Access Compliance Report

Public Rights-of-Way

(Curb Ramps)

Intersection ID: 21503	Main Street: BLUEBERRY_LN	Cross Street: PROVIDENCE_RD	Location: NW
ADA ID: 3B19259CB0BB	Ramp Type: PerpDiag	Initial Pass/Fail: Fail	Overall Compliance: No
		Severity Score: 10

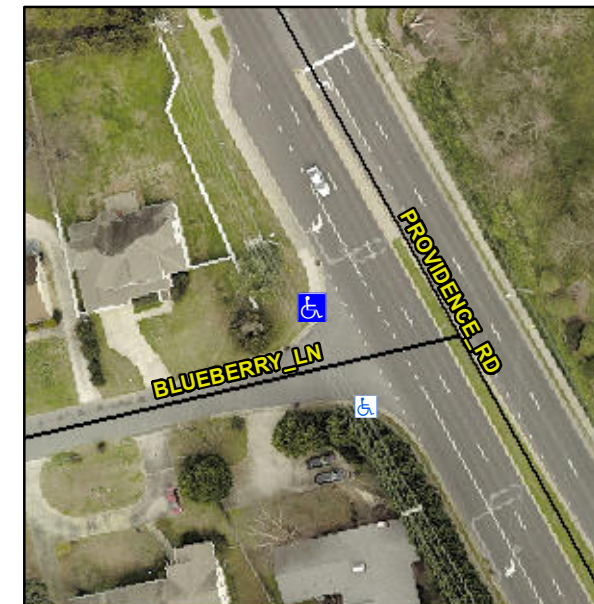
Not Found, R304.5.1, R304.5.3

Compliance	Description	Data	Compliance	Description	Data
N/A	Ramp Length (in)	72.0	Yes	Ramp Slope (%)	5.1
No	Ramp Width (in)	47.5	No	Ramp XSlope (%)	3.0
N/A	Flare Type LT	N/A	N/A	Flare Type RT	N/A
N/A	Flare Slope LT (%)	N/A	N/A	Flare Slope RT (%)	N/A
N/A	Flare Traversable LT?	N/A	N/A	Flare Traversable RT?	N/A
N/A	Landing Length (in)	N/A	N/A	DWS Provided?	N/A
N/A	Landing Width (in)	N/A	N/A	DWS Contrast?	N/A
N/A	Landing Slope (%)	N/A	N/A	DWS Length (in)	N/A
N/A	Landing X Slope (%)	N/A	N/A	DWS Full Width?	N/A
N/A	Landing Curb? (Y/N)	N/A	N/A	DWS Offset (in)	N/A
N/A	Shared Landing?	N/A			
N/A	Gutter Ponding?	N/A	N/A	Gutter Slope (%)	N/A
N/A	Gutter Lip Ht (in)	N/A	N/A	Gutter X Slope (%)	N/A
N/A	Painted X Walk1?	No	N/A	Painted X Walk2?	No
	X Walk 1 Direction	To S		X Walk 2 Direction	To E
N/A	X Walk 1 Width (in)	N/A	N/A	X Walk 2 Width (in)	N/A
	X Walk 1 Slope (%)	0.3		X Walk 2 Slope (%)	3.1
	X Walk 1 X Slope (%)	3.5		X Walk 2 X Slope (%)	1.7

Remove & Replace Curb Ramp With Two New Directional Ramps or Equivalent.
